# STATEMENT OF RESPONSE TO AN BORD PLEANÁLA'S CONSULTATION OPINION

PREPARED FOR WESTERN WAY  
DEVELOPMENTS LTD

**IN RESPECT OF A  
PROPOSED SHARED LIVING AND NEIGHBOURHOOD USES  
SCHEME AT THE  
HENDRONS BUILDING AND WIDER SITE, 36-40 DOMINICK  
STREET UPPER, DUBLIN 7**

**DECEMBER 2020**

**Figure 24 – Typical floor plan showing locations of LKD spaces throughout the site**

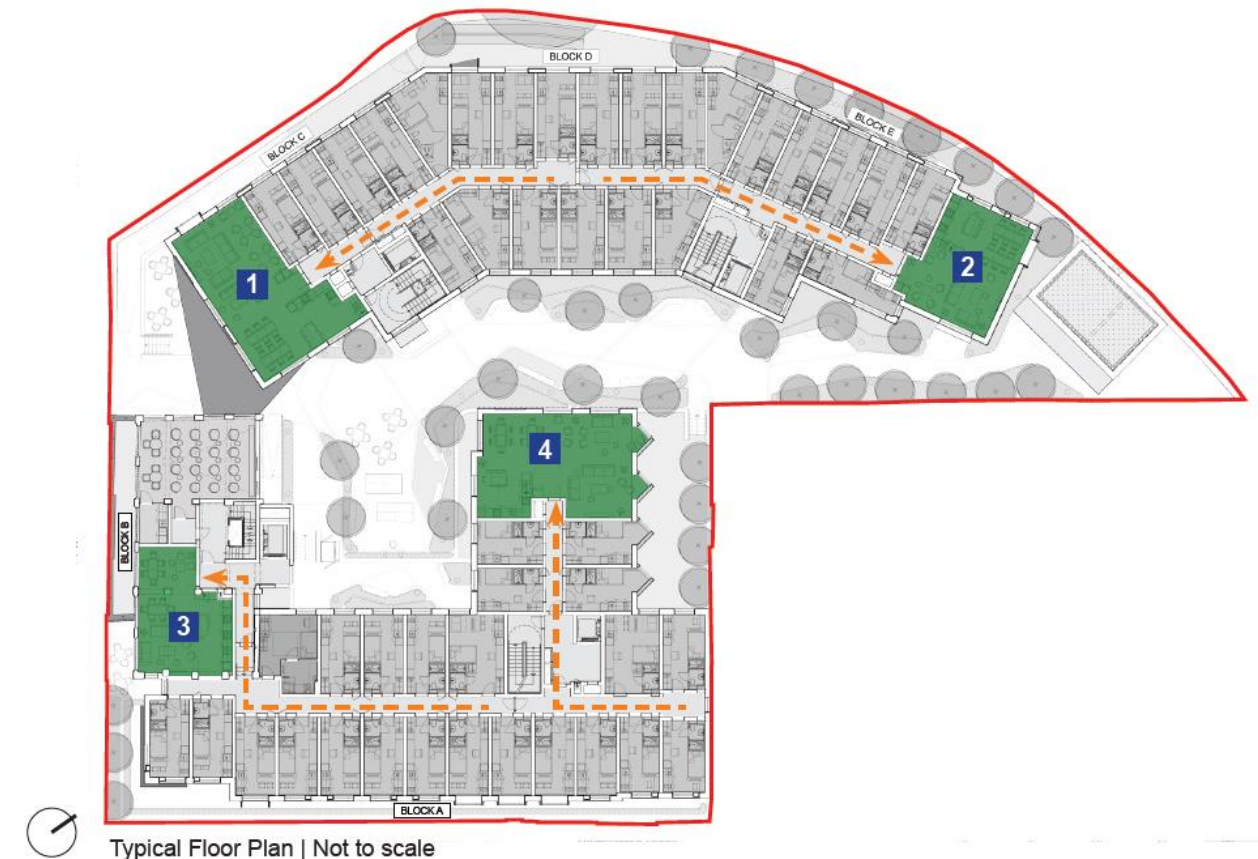
“A detailed schedule of accommodation demonstrating compliance with the relevant standards set out in the Sustainable Urban Housing: Design Standards for New Apartments Guidelines for Planning Authorities, in relation to Shared Accommodation Developments, including SPPR9, in particular.”

2.51 We refer the Board to the enclosed Statement of Consistency and Planning Report which provides a detailed response to the criteria outlined in relation to Shared Accommodation Developments, including SPPR9 within the *Sustainable Urban Housing: Design Standards for New Apartments Guidelines for Planning Authorities*. In addition, a Schedule of Accommodation and a Housing Quality Assessment has been prepared by John Fleming Architects. In addition, the Architectural Design Statement includes a specific response to the above item as follows;

*“The proposed ratio of LKD for the scheme is 6.2 sq.m. per resident (1739.4 sq.m./281 no. residents). For further detail on bedrooms sizes and distribution of the LKD areas on all floor levels please consult floor plan drawings and the “Housing Quality Assessment” submitted as part of this application.*

- The proposed LKD units are located in areas of the building with great daylight exposure and with views to either the city or into the courtyard;
- The LKD units size on each floor depends on the number of residents they serve. This will balance the proposed ratio of LKD area per resident through the scheme;
- If we use the typical floor as an example to illustrate the previous items (please see image below) it is evident that the LKD rooms in blocks A and B are similar in size to the LKD rooms in blocks C, D and E. LKD-1 and LKD-2 will serve the 25 no. residents on blocks C, D and E, the area of the two spaces is 155.0 sq.m. which represents 6.2 sq.m of LKD per resident. LKD-3 and LKD-4 will serve the 24 no. residents on blocks A and B, the area of the two spaces is 148.2 sq.m. which represents 6.2 sq.m of LKD per resident.’
